SUBJECT: Final Report on the DOE/SC Review of the SNS Target Design  
and Operations, February 2015

# **Spallation Neutron Source Target Design and Operations**

**at Oak Ridge National Laboratory**

**February 2015**

**5. *Evaluate possible power level dependent stress sources on the target in light of the operating history of the 11 targets installed at SNS since 2009.***

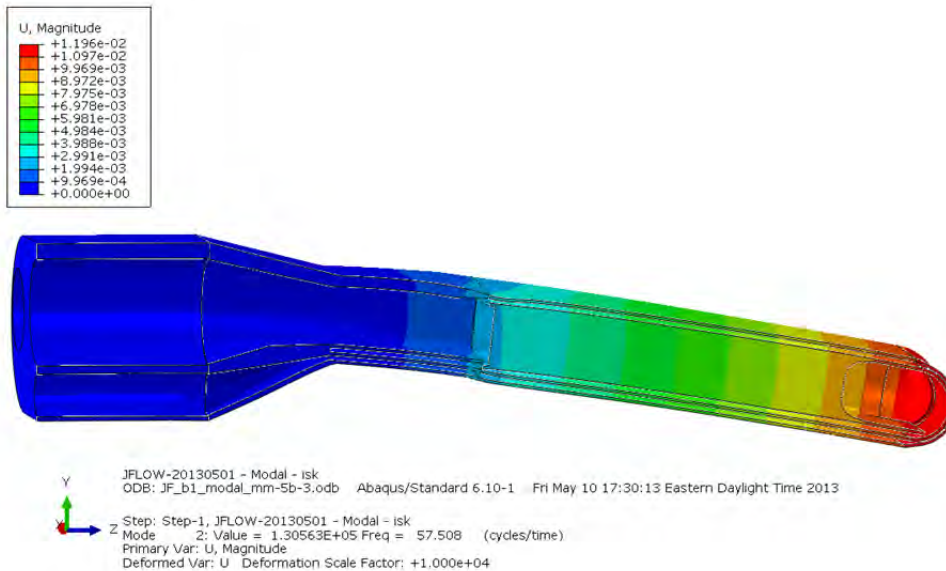
The proposed correlation of successful high power target life after extended initial operation at limited power is based on low statistics and lacks credible causation. The transition stress reduction associated with fracture of the inner beam window is based on overly simple modeling of crack behavior and should not be relied upon. Running at initial low power for several weeks is not justified as a means to assure long life at higher power.

Higher power clearly results in higher pressure pulse and thermal stress for a given design and mercury flow. Investigating design changes that reduce stresses due to the pressure pulse (e.g., helium bubble injection) and thermal gradients (e.g., thinning or removing the center baffle) should be pursued over attempts to “break-in” targets at low power before operating at high power.
